Agenda
Monterey Peninsula Regional Water Authority (MPRWA)
Regular Meeting

SUBJECT: Receive, Discuss, and Approve the Final Comment Letter to the California Public Utilities Commission (CPUC) on The Monterey Peninsula Water Supply Project Draft Environmental Impact Report

RE: Water Authority Comments on the Monterey Peninsula Water Supply Project DEIR

Figure 2

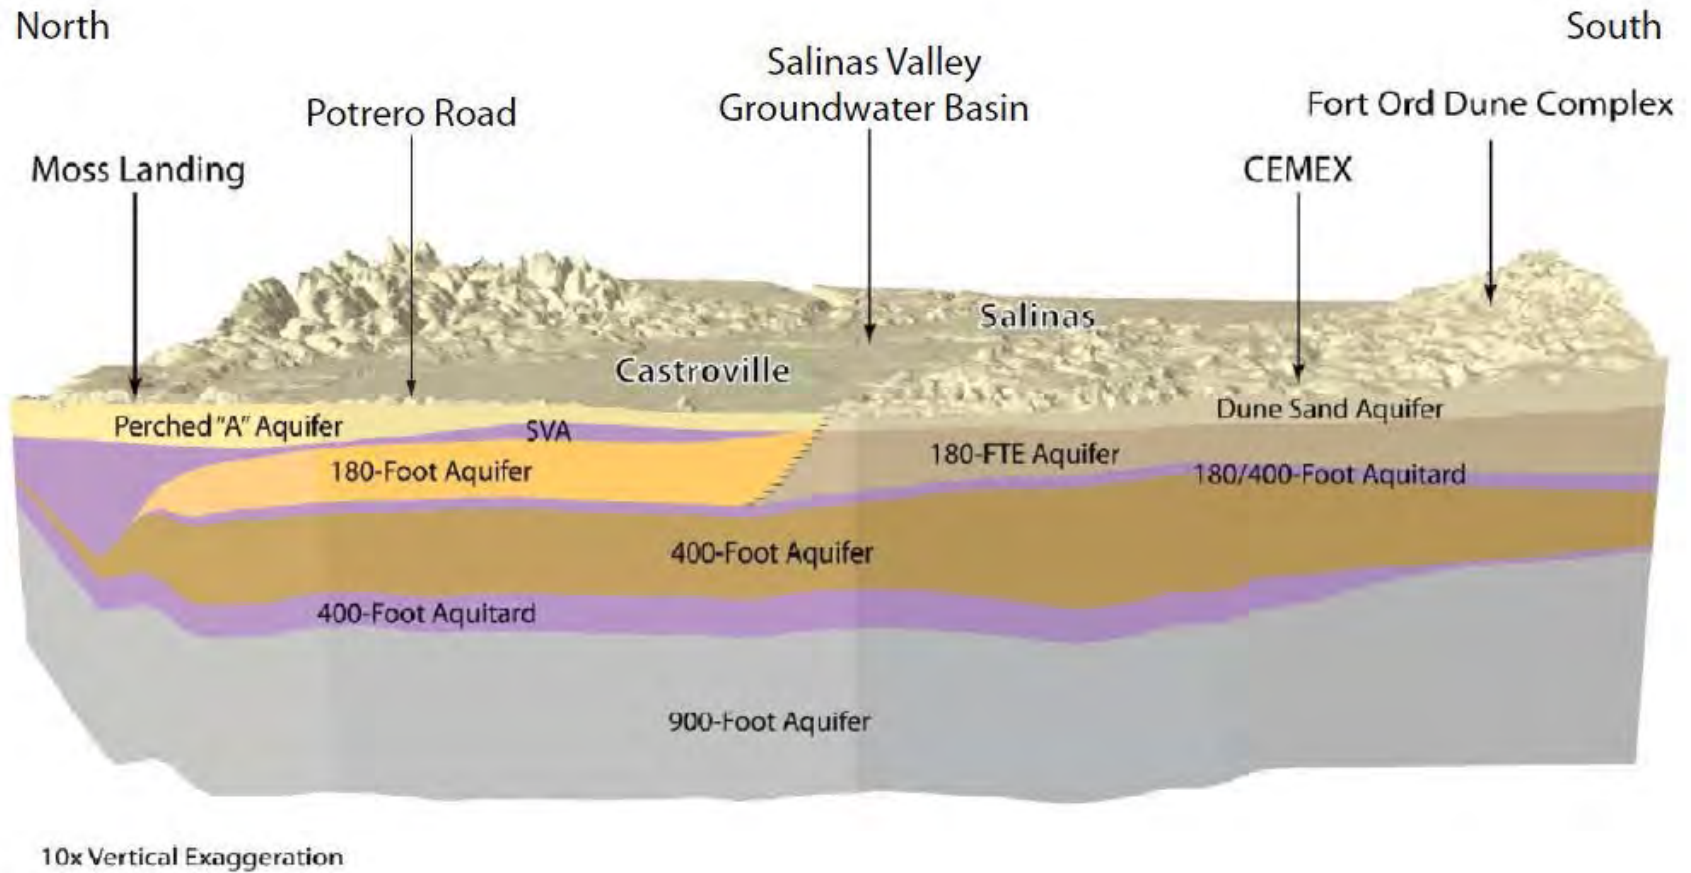
The models represent some of the slant wells extending well beneath the sea floor (**Figure 2**), but the actual slant wells may not reach that far. For example, the test well just reaches the ocean margin where the well screen is approximately 225 ft beneath the ocean floor (**see Figure 1B**). If the actual slant wells are further from the ocean than the model slant wells, the model runs that have been conducted may overestimate hydraulic connection between the slant well intakes and the Ocean. We recommend that a sensitivity analysis be performed on influence on the model results of the location of the slant wells relative to the coastal margin. **Note, however, that the portions of Ocean Water and Inland Fresh Groundwater pumped by the slant wells can ultimately be determined from actual measurements of the intake water salinity, not by modeling.**

14

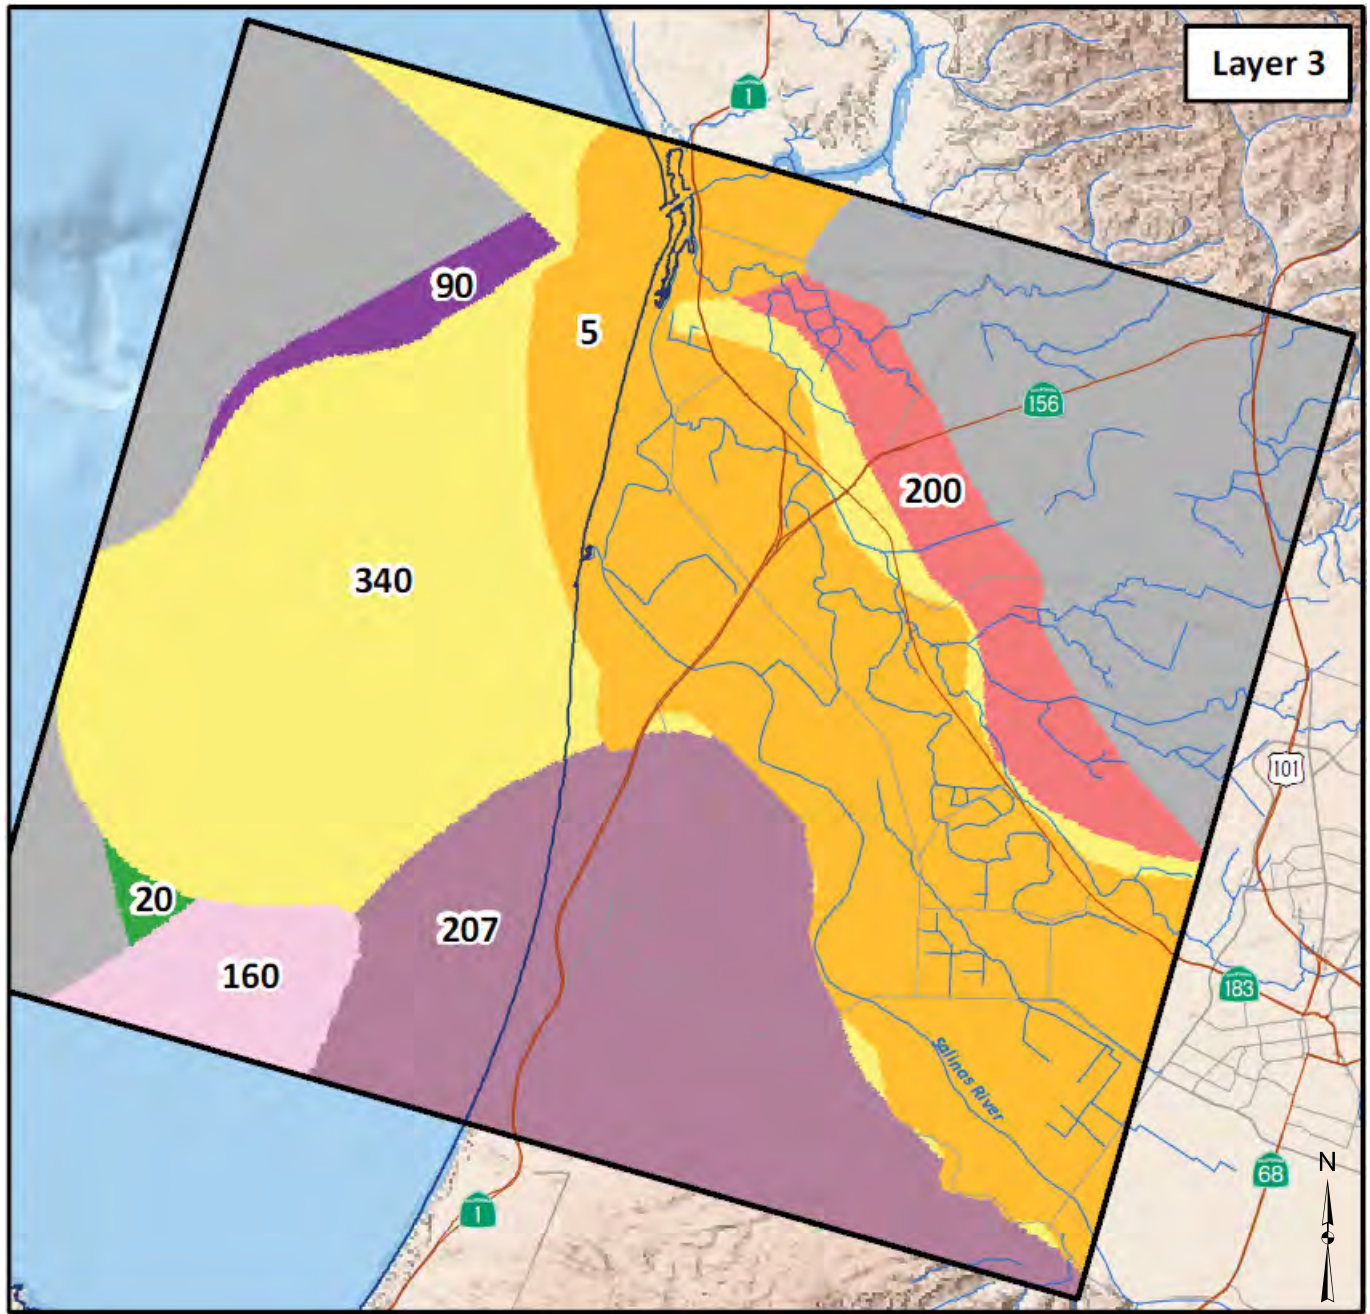
The DEIR reports that borings at the CEMEX site show that low permeability clay layers between Dune Sand and 180-FTE Aquifers, which are present inland, do not extend offshore. However, as illustrated by **Figure 14** the model includes a relatively low permeability layer (Model Layer 3, Horizontal Hydraulic Conductivity, $K_h = 5$ ft/d) between the Dune Sand and 180 FTE Aquifers extending offshore. Consequently, as reported in the DEIR, the model may underestimate the hydraulic connection between the 180-FTE Aquifer with the Dune Sand Aquifer and the Ocean.

- Conservatively low Kh (5 ft/d) between Dune sand and 180-FTE Aquifers at Coastline (Model Layer 3).

Kv in NMGWM Layer 2v

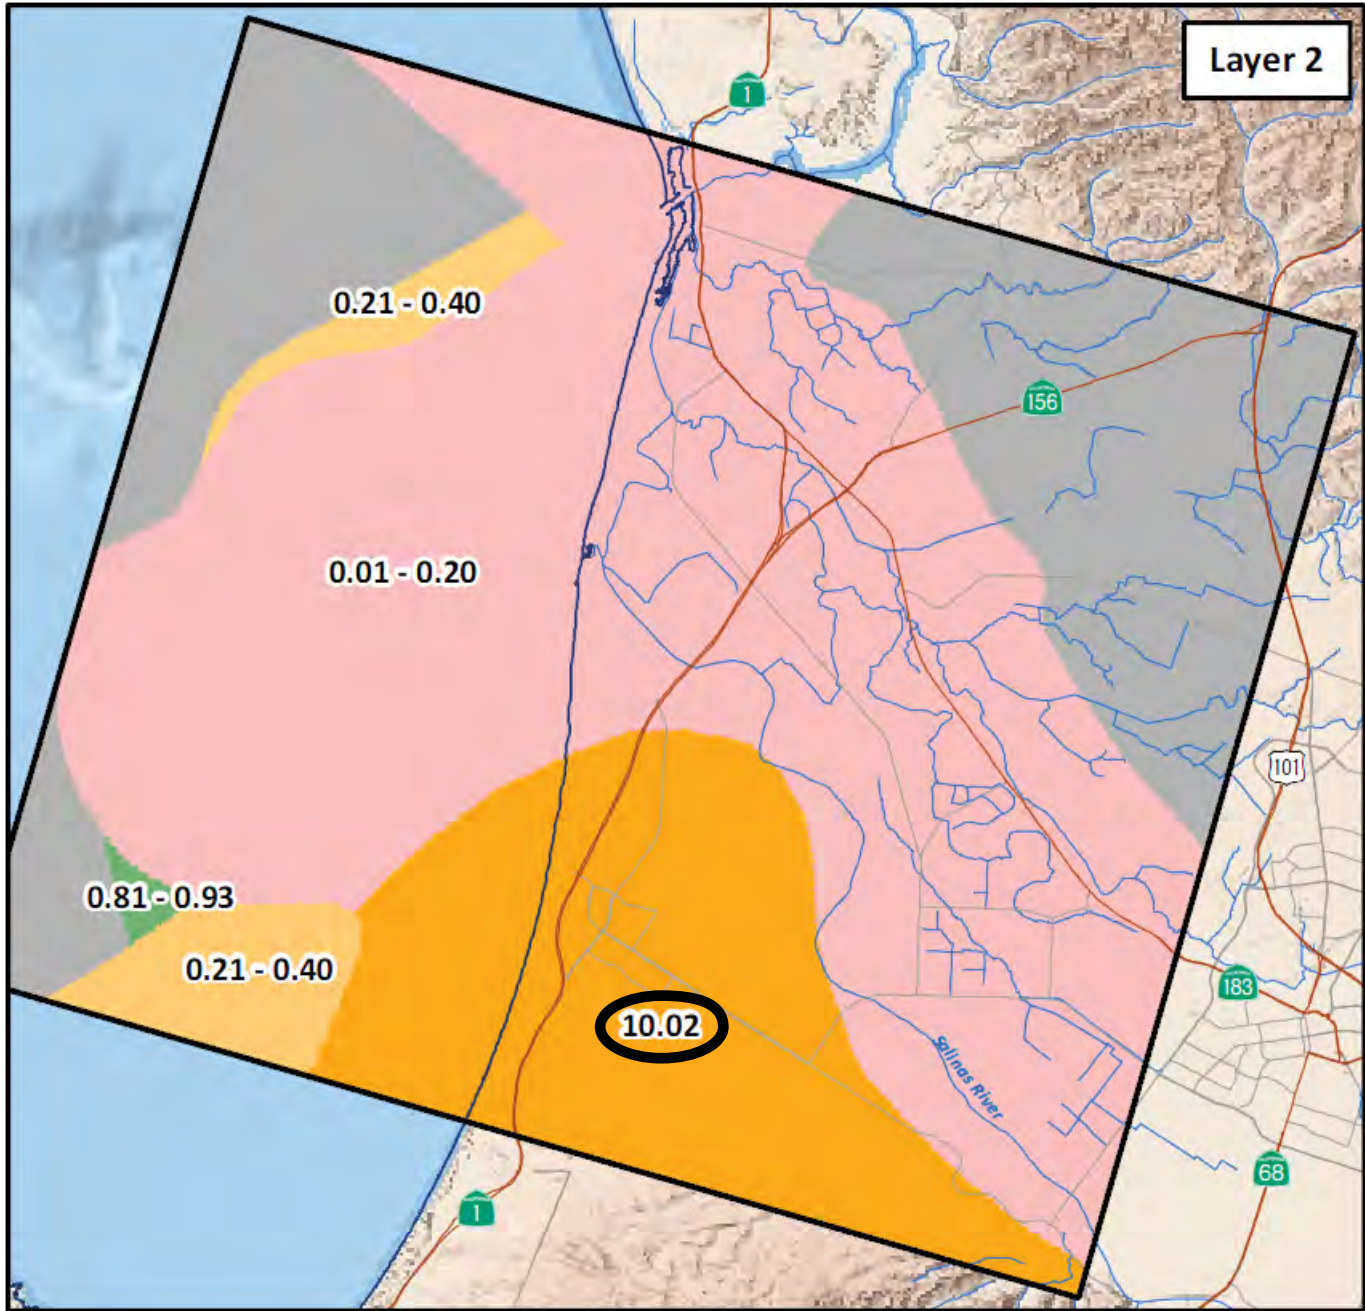
Vertical Hydraulic Conductivity (K_v) values of ~10 ft/d in the NMGWM (see **Figure 15**) and K_v values up to 47 ft/d in the CM assigned to some of the Dune Sand aquifer may be optimistically high and may result in the model overestimating the portion of intake water derived from the ocean and underestimating the portion of intake water derived from inland.

Thus, the models may overestimate local hydraulic connection between the 180-FTE and Dune Sand Aquifers with the Ocean. In particular the K_v values discussed above may need to be revised in the NMGWM based on calibration of the CEMEX model to the long-term pumping test of Slant Well currently in progress.

- Hi Kv (10 ft/d) for Dune Sand Aquifer (Model Layer 2) may overestimate hydraulic connection to the Ocean.
